**Re: GE-Pittsfield/Housatonic River Site
Lyman Street Area (GECD430) – Properties East of Lyman Street
Supplemental Information Package Addendum**

Revised Final Grading Plan

GENERAL ELECTRIC COMPANY • PITTSFIELD, MASSACHUSETTS
 LYMAN STREET AREA REMEDIAL ACTION
ENGINEERED BARRIER
FINAL GRADE PLAN
 TECHNICAL DRAWINGS

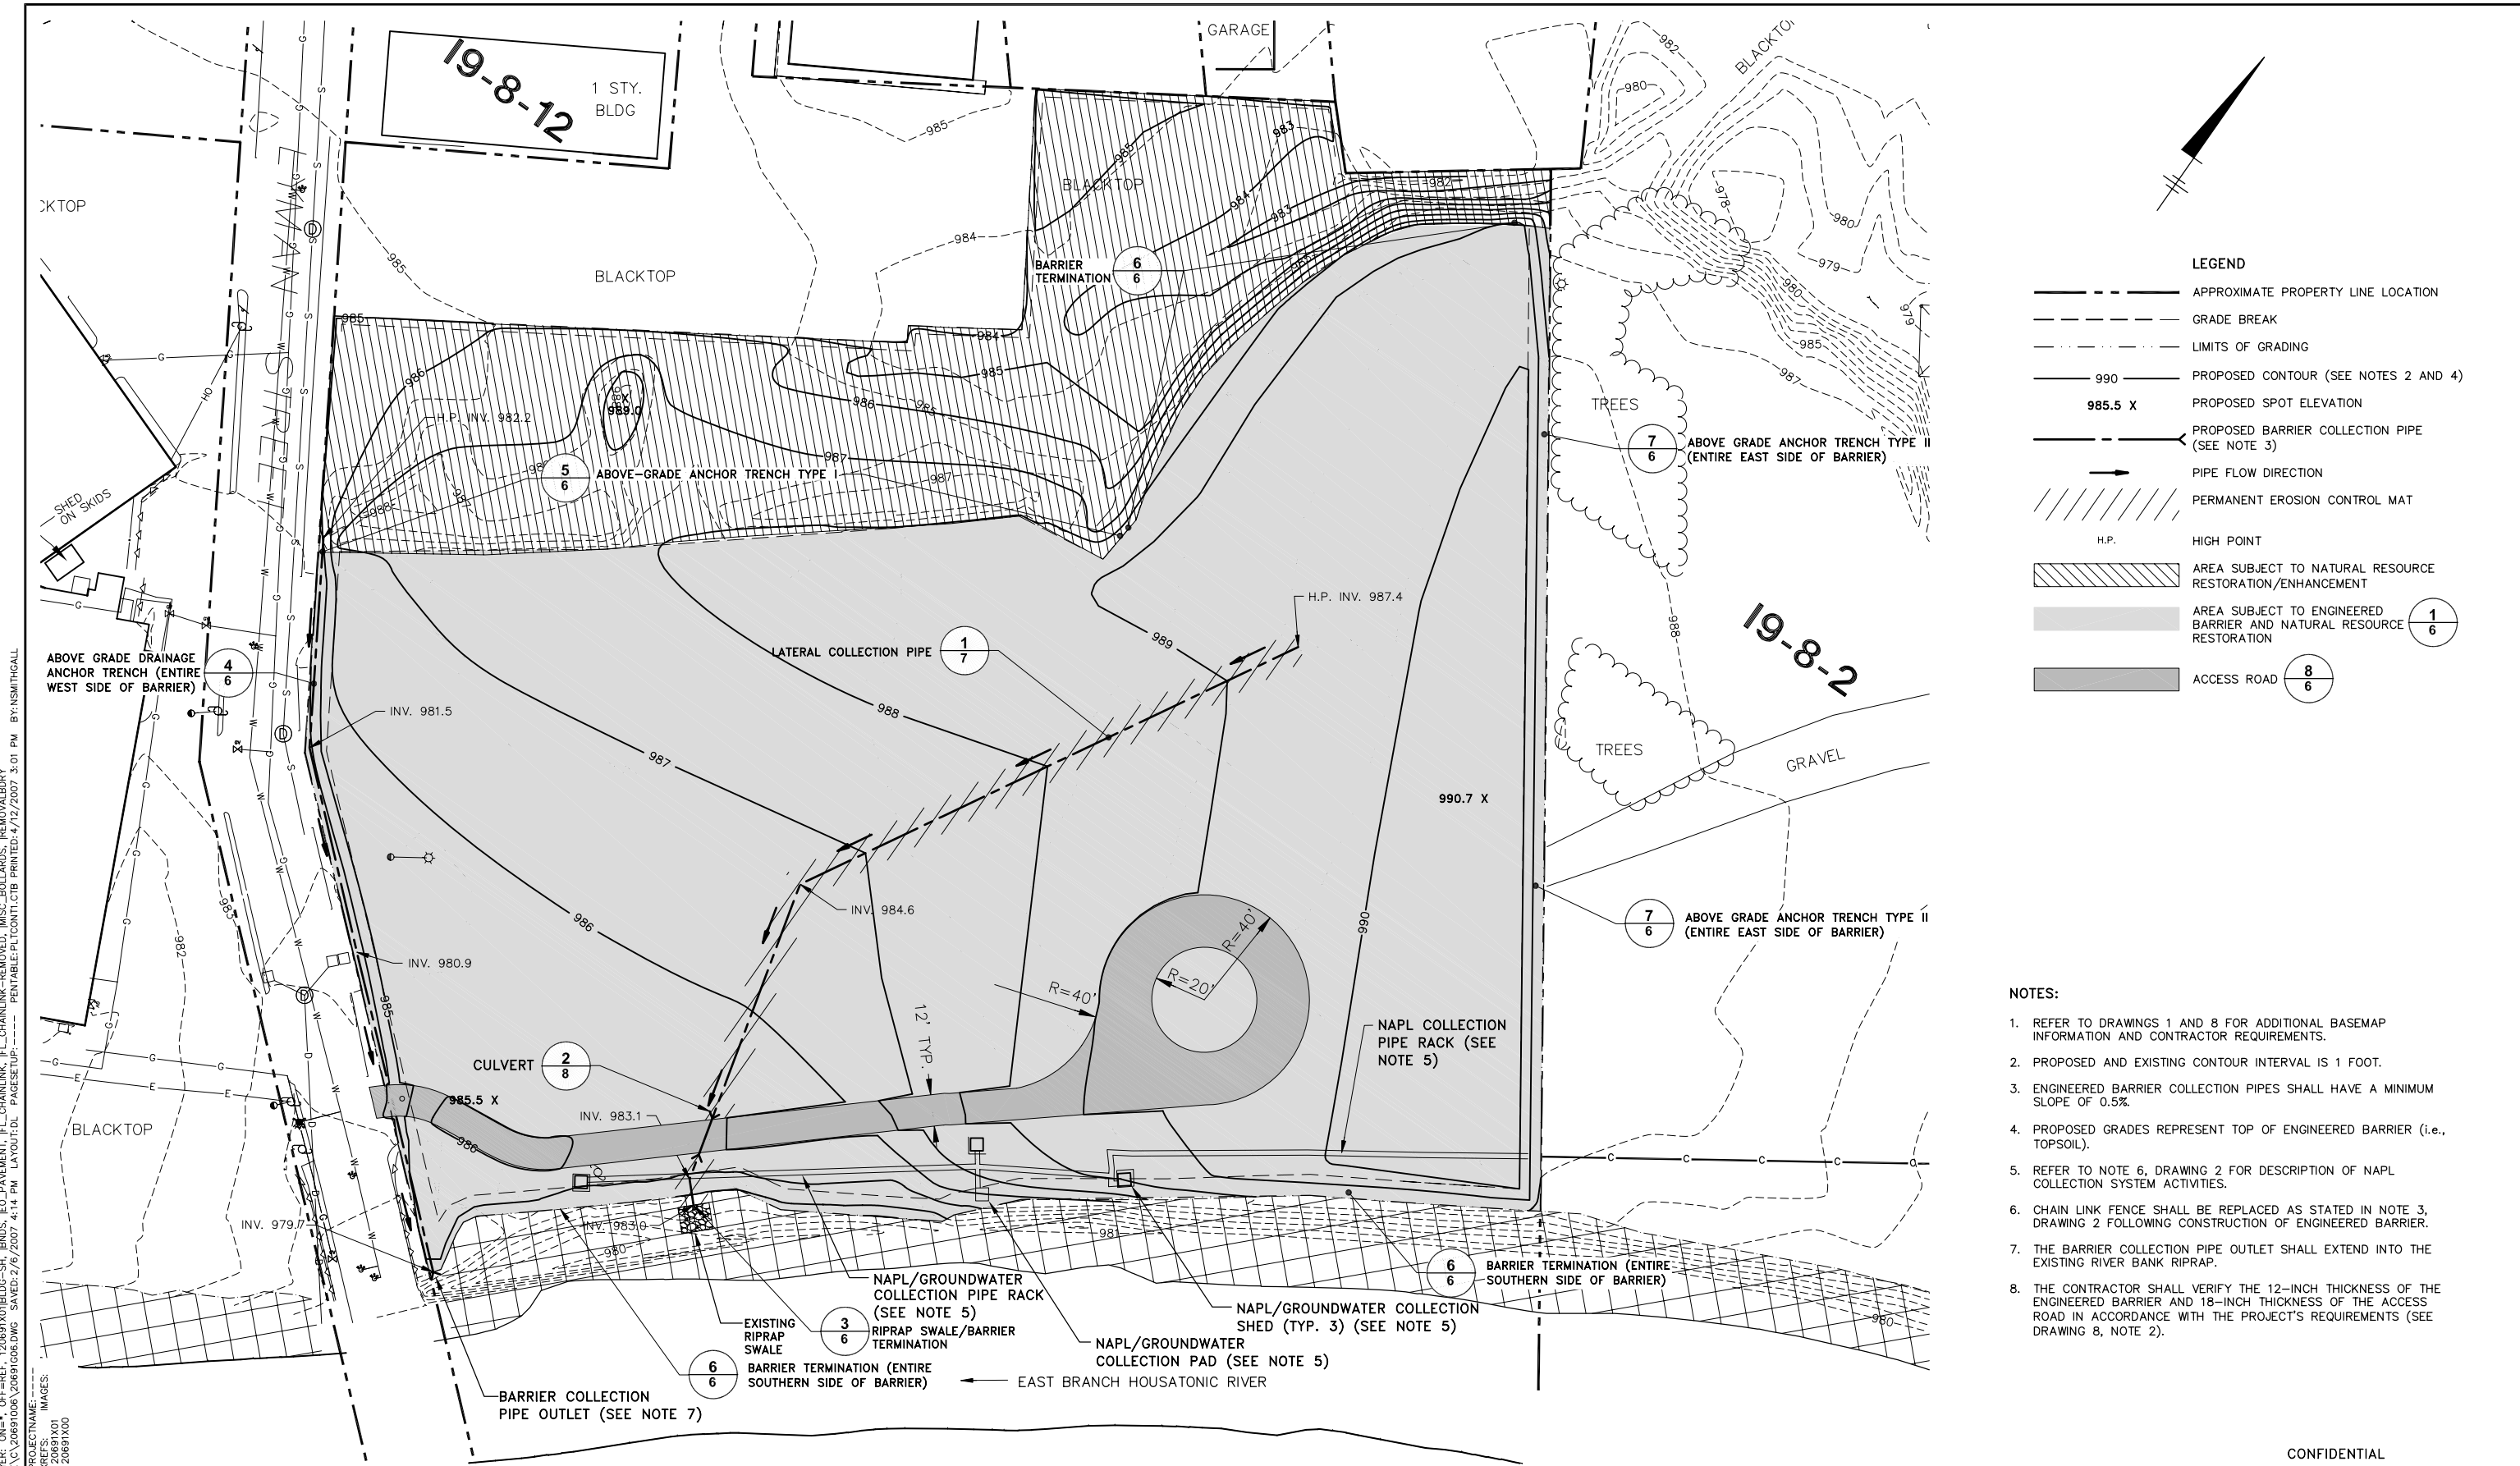
For the area north of the engineered barrier on parcel I9-8-1 that is subject to Natural Resource Restoration/Enhancements, GE shall provide a revised grading plan that illustrates and requires the placement of a minimum of three inches of topsoil to support the growth and sustainability of future vegetation in this area.

As shown on Attachment 1, a revised final grading plan has been prepared for the northern portion of Parcel I9-8-1. As part of the revised final grades, 3 inches (minimum) of topsoil will be placed above imported soil fill material.
